Submission - Julius Ave Data Centre Amendments – 18/03/26

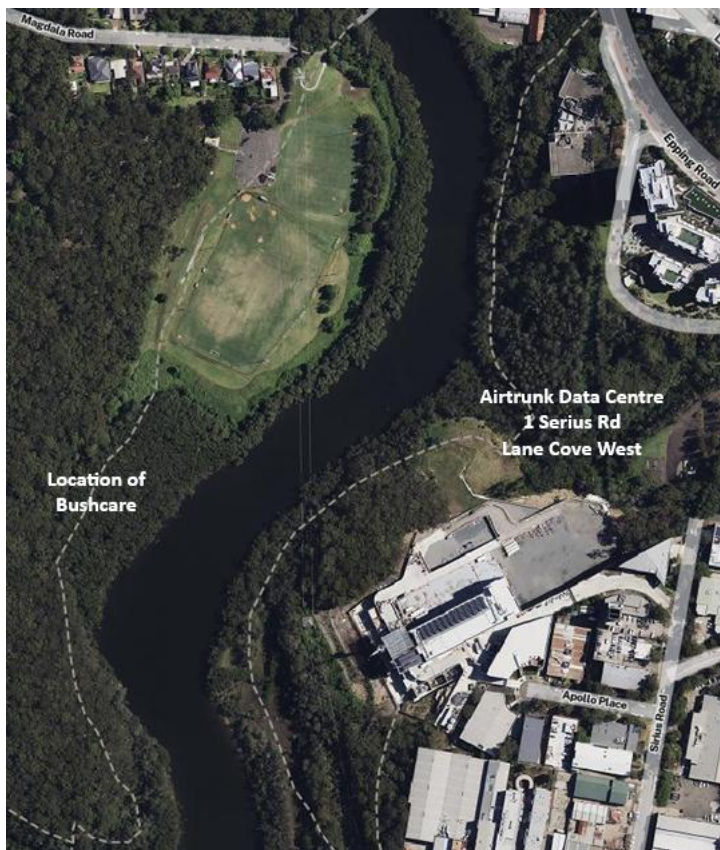
3) Habitat corridor

The project will affect a narrow corridor which allows fauna to move between Pages Creek in the south-west of the photo and Fairyland in the east. Can we be sure that construction works and ongoing operational disruptions like noise will not significantly adversely impact the migration of fauna through this wildlife corridor?
